PIC16(L)F1824/1828 Family Silicon Errata and Data Sheet Clarification

The PIC16(L)F1824/1828 family devices that you have received conform functionally to the current Device Data Sheet (DS40001419E), except for the anomalies described in this document.

FIGURE 1: INSTRUCTION CYCLE DELAY CALCULATION EXAMPLE

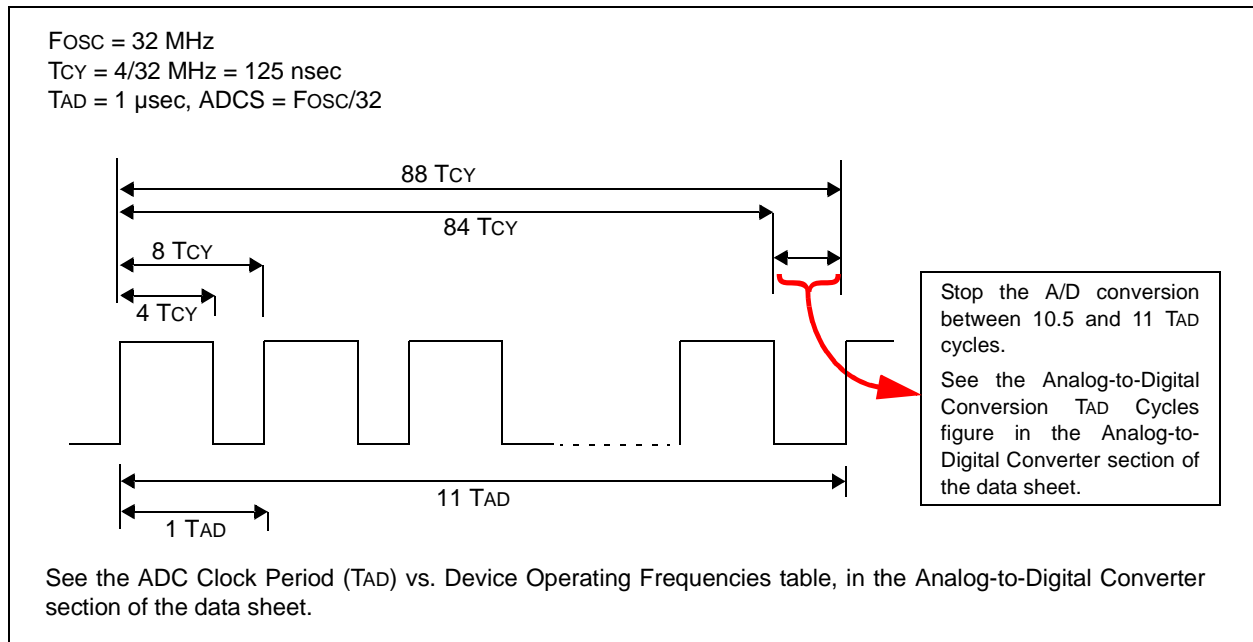
An ADC conversion may not complete under these conditions:

1. When FOSC is greater than 8 MHz and it is the clock source used for the ADC converter.
2. The ADC is operating from its dedicated internal FRC oscillator and the device is not in Sleep mode (any FOSC frequency).

When this occurs, the ADC Interrupt Flag (ADIF) does not get set, the GO/DONE bit does not get cleared, and the conversion result does not get loaded into the ADRESH and ADRESL result registers.

Method 3: This method is provided if the application cannot use Sleep mode and requires continuous operation at frequencies above 8 MHz. This method requires early termination of an ADC conversion. Provide a fixed time delay in software to stop the A-to-D conversion manually, after all 10 bits are converted, but before the conversion would complete automatically. The conversion is stopped by clearing the GO/DONE bit in software. The GO/DONE bit must be cleared during the last 1/2 TAD cycle, before the conversion would have completed automatically. Refer to Figure 1 for details.

In Figure 1, 88 instruction cycles (Tcy) will be required to complete the full conversion. Each TAD cycle consists of 8 Tcy periods. A fixed delay is provided to stop the A/D conversion after 86 instruction cycles and terminate the conversion at the correct time as shown in the figure above.

Note: The exact delay time will depend on the TAD divisor (ADCS) selection. The Tcy counts shown in the timing diagram above apply to this example only. Refer to Table 3 for the required delay counts for other configurations.
